UNITED STATES PATENT AND TRADEMARK OFFICE

APPLICATION NO.	FILING DATE	FIRST NAMED INVENTOR	ATTORNEY DOCKET NO.	CONFIRMATION NO.
10/829,610	04/22/2004	Ian D. Parker	UC0306USNA	6868

Office Action Summary

DETAILED OFFICE ACTION

FIG. 5

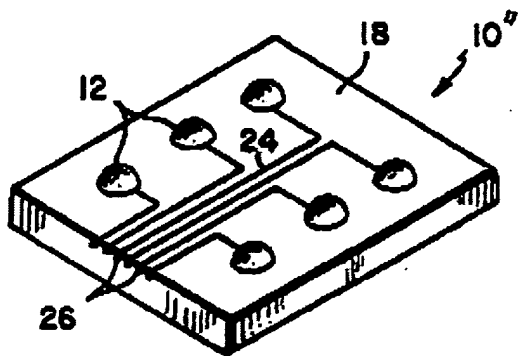
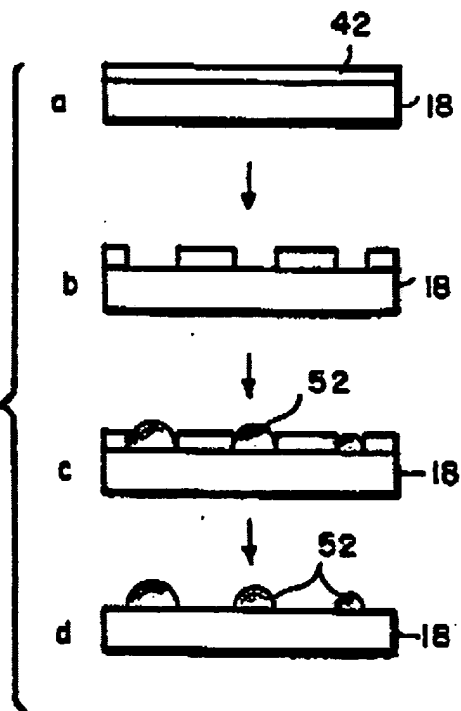
Rothschild (in the abstract, in fig 4, in fig 5, column 2 line 4-15) a device comprising: a substrate having a surface with a first portion and a second portion, without a well structure connected to or adjacent the first portion of the surface or the second portion of the surface, wherein the first portion of the surface has a first surface energy and the second portion of the surface has a second surface energy; and a liquid composition covering the first portion of the surface and contacting the second portion of the surface, wherein the liquid composition has a third surface energy that is higher than the first surface energy and lower than the second surface energy.

Moreover, even though Rothschild does not disclose that the liquid composition covering the first portion this limitation is either inherent from Rothschild disclosure since the Rothschild method and Applicant method is the same and therefore results in the same structure. That means

there are some partial covering of the first portion in the disclosure by Rothschild and effectively make it anticipates claim 11.

Noted that when a liquid composition is dropped over a substrate it will adhere primarily to the portion that has higher surface energy as disclosed by the Applicant in fig 9 and page 27 lines 1-5 of Applicant Specification in agreement with the disclosure by Rothschild on column 2 lines 15-16 of his disclosure.

Fig.7(a).
Self-alignment with large
wettability contrast

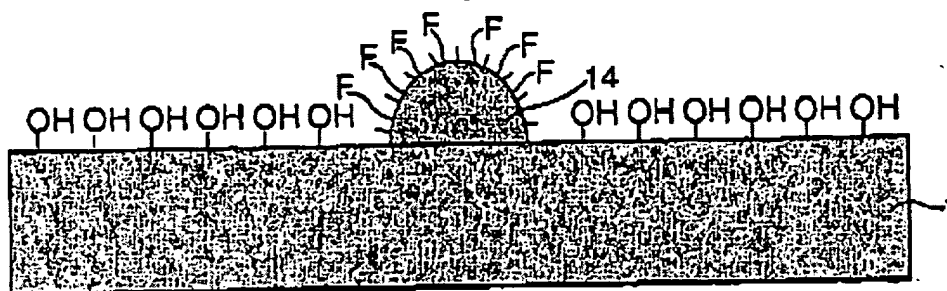
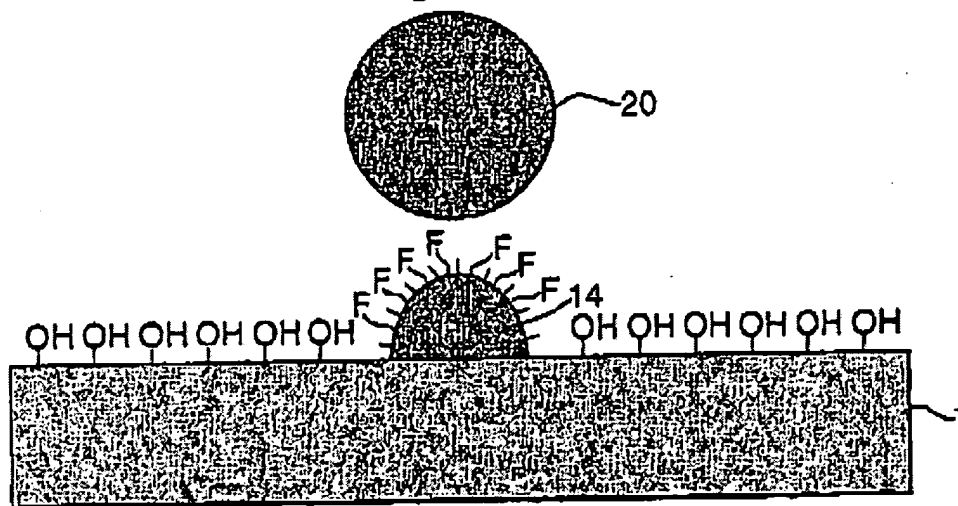
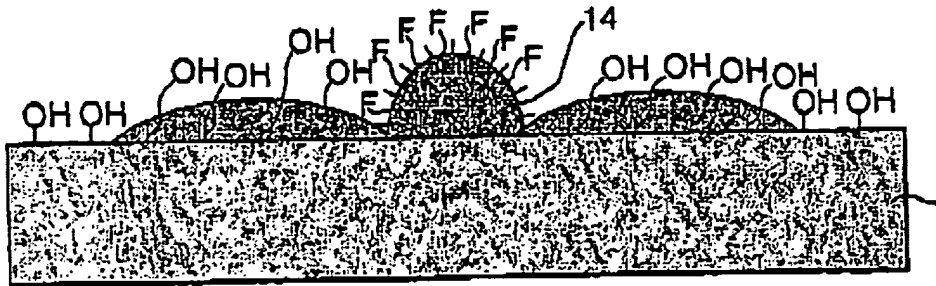
Takeo discloses (in fig 7(a), 7(b), 7(c)) the use of Fluorine surfactant.

The rationale why claim 15,16 is obvious over the Takeo 361 reference has been discussed in the rejection of claim 12.

Fig. 2

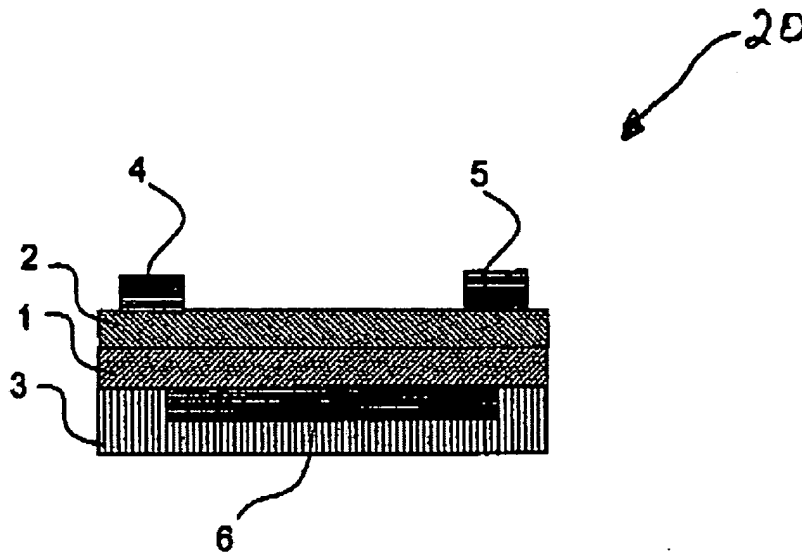
Mori (fig 2) disclose all the invention including a substrate with a portion that has electrode (fig 2 layer 6) and a portion with insulation layer (fig 2 layer 3).

Missing in the Mori disclosure is the specific formation of the organic electronics device using surface energy.

Takeo, however, in the abstract, discloses how to use the surface energy to pattern organic electronics device. It would have been obvious to one of ordinary skill in the art to combine the teachings by Ohtani with Takeo in order to come up with the invention of claim 13.
